Product Change Notification / GBNG-16RJZN641

CCB 4279.001 Final Notice: Qualification of GTK as a new assembly site for selected SST38VF640xx, SST39LF40xx and SST39VF40xx device families available in 48L TSOP (12x20mm) package.

CCB 4279.001
Pre and Post Change Summary
PCN #: GBNG-16RJZN641

LPI

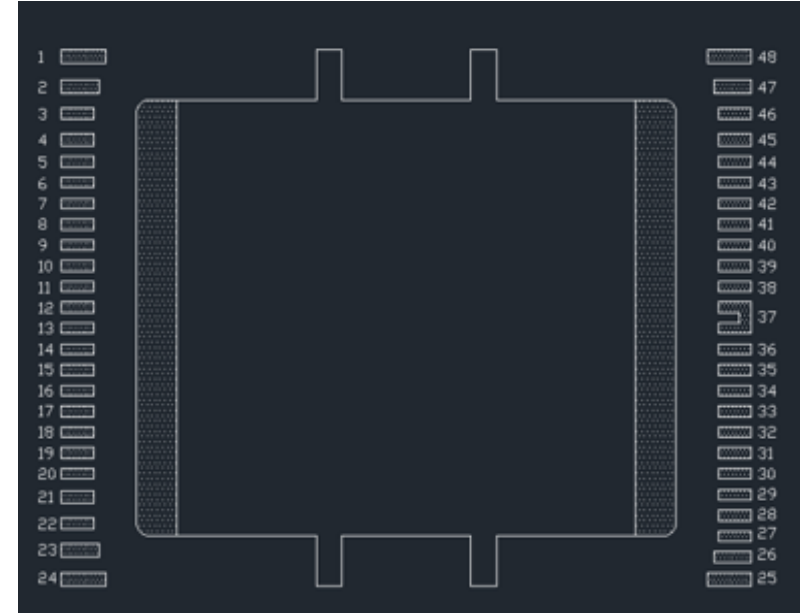
Lead frame Comparison

Paddle size

162 x 260 mils

GTK

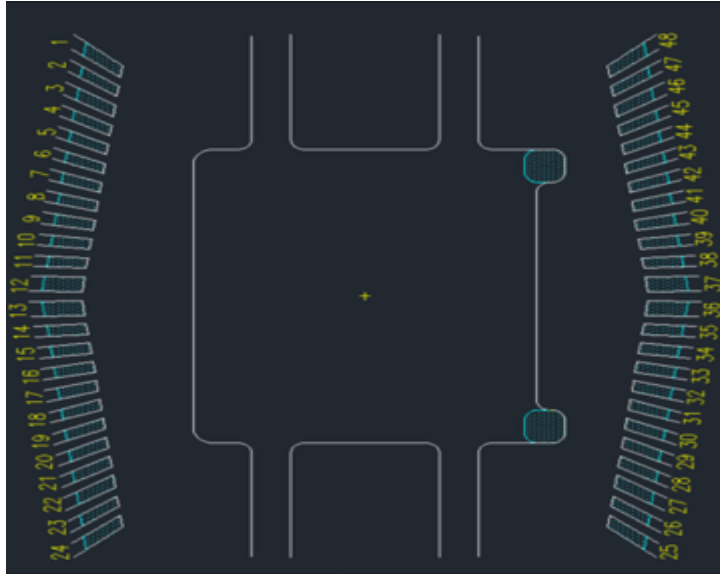
Paddle size

330 x 260 mils

LPI

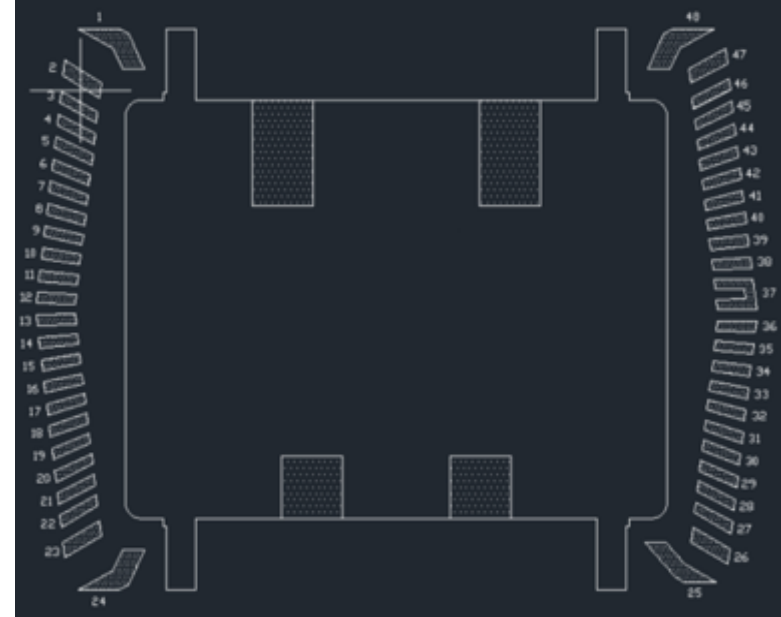
Lead frame Comparison

Paddle size

160x130 mils
